SB Number:	SB 2BZ-004	Creation Date: 06/04/2004
Subject:	Dog ear in paper (Fuser unit change)	
Model:	FS-6020 (FK-400)

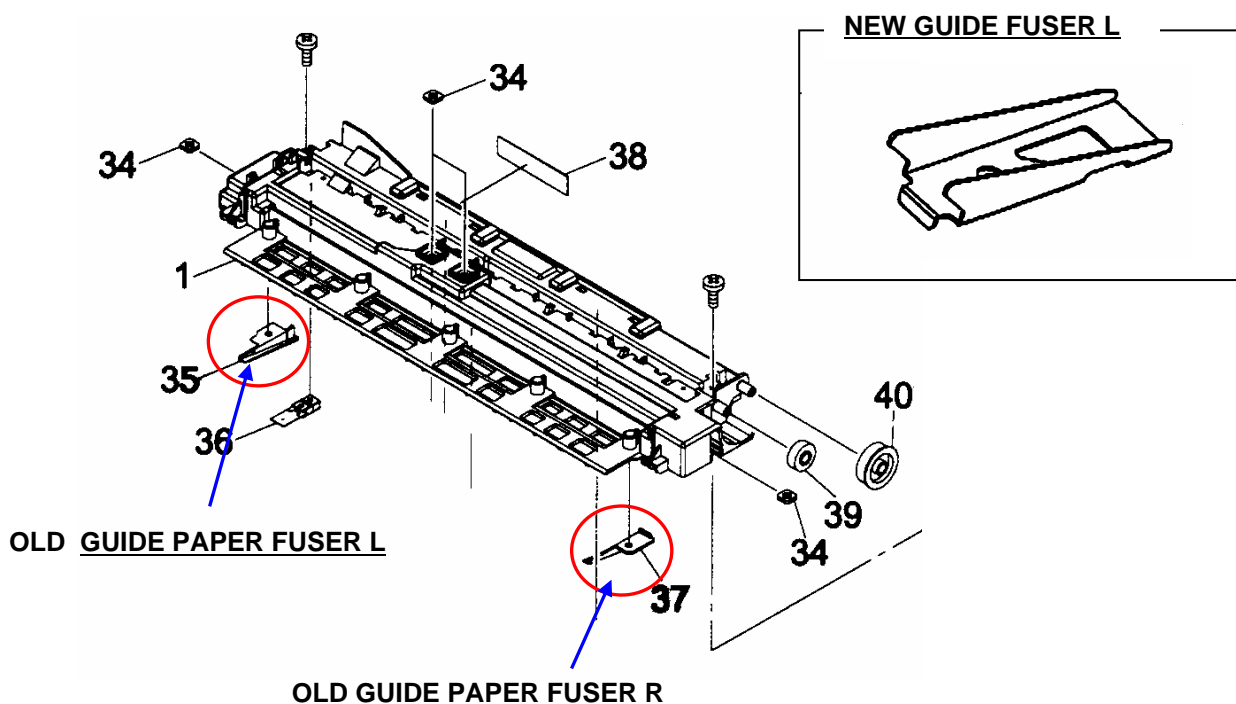
Dog's ear in the ejected paper.

The material and shape of the 'GUIDE PAPER FUSER L/R' has been changed.

The shape of both the 'GUIDE PAPER FUSER L' and 'GUIDE PAPER FUSER R' has been unified to improve the productivity and the work efficiency.

OLD: resin / **NEW:** sheet metal
